## 1 Products affected

## 2 Type of change

| Product Change Notification |               |              |             |              | PCN CD, CE, CG - TOX, Label w/o P/N |        |             |

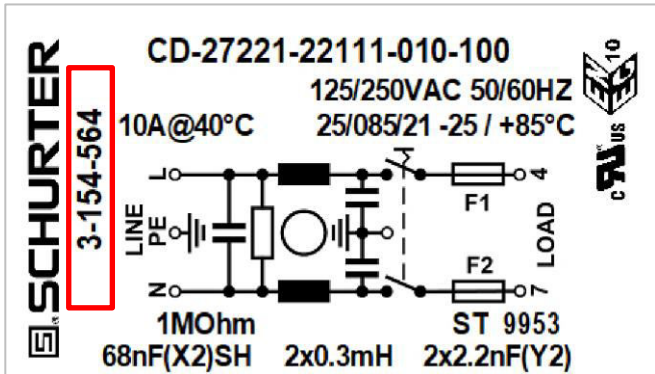
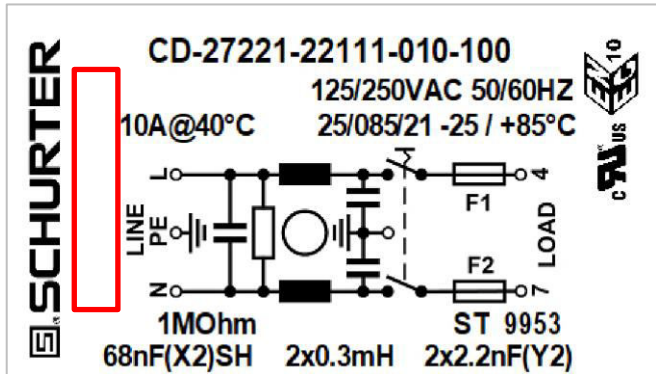
| Current product appearance                                                                                                                                                                                                       | New product appearance                                                                                                                                                                                                            |
|----------------------------------------------------------------------------------------------------------------------------------------------------------------------------------------------------------------------------------|-----------------------------------------------------------------------------------------------------------------------------------------------------------------------------------------------------------------------------------|
| Spot welding joint                                                                                                                                                                                                               | TOX clinching joint                                                                                                                                                                                                               |

- Production process improvement: Change from spotwelding to TOX clinching
- Production optimisation: Separation of the part and the packaging unit; the configuration code remains on the product, and the item numbers are printed on the packaging label.
- This change is part of the continuous improvement process

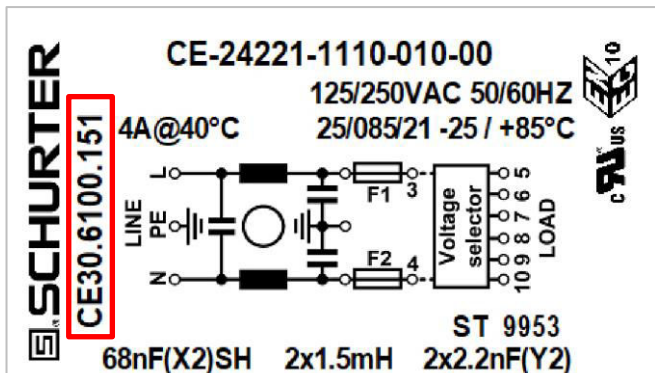
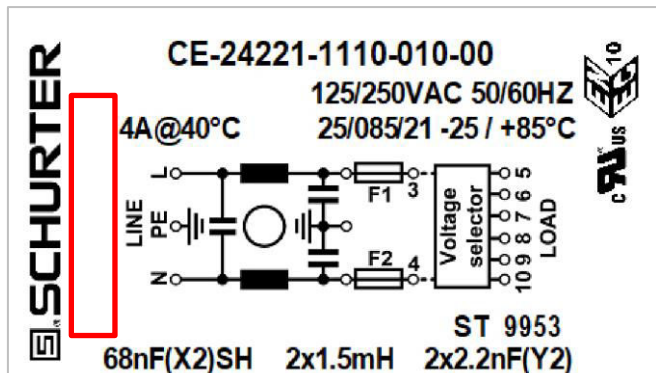
| Current product appearance                                                                                                                                                                                                       | New product appearance                                                                                                                                                                                                            |
|----------------------------------------------------------------------------------------------------------------------------------------------------------------------------------------------------------------------------------|-----------------------------------------------------------------------------------------------------------------------------------------------------------------------------------------------------------------------------------|
|  <p>CD-27221-22111-010-100<br/>125/250VAC 50/60HZ<br/>10A@40°C 25/085/21 -25 / +85°C<br/>1MOhm 68nF(X2)SH 2x0.3mH 2x2.2nF(Y2)<br/>ST 9953</p> |  <p>CD-27221-22111-010-100<br/>125/250VAC 50/60HZ<br/>10A@40°C 25/085/21 -25 / +85°C<br/>1MOhm 68nF(X2)SH 2x0.3mH 2x2.2nF(Y2)<br/>ST 9953</p> |
|  <p>CE-24221-11110-010-00<br/>125/250VAC 50/60HZ<br/>4A@40°C 25/085/21 -25 / +85°C<br/>1MOhm 68nF(X2)SH 2x1.5mH 2x2.2nF(Y2)<br/>ST 9953</p>   |  <p>CE-24221-11110-010-00<br/>125/250VAC 50/60HZ<br/>4A@40°C 25/085/21 -25 / +85°C<br/>1MOhm 68nF(X2)SH 2x1.5mH 2x2.2nF(Y2)<br/>ST 9953</p>   |

- Improvement of manufacturing process
- P/N removed from product label

| <input checked="" type="checkbox"/> Label         | No action required, 2D Barcode on package label remains unchanged |
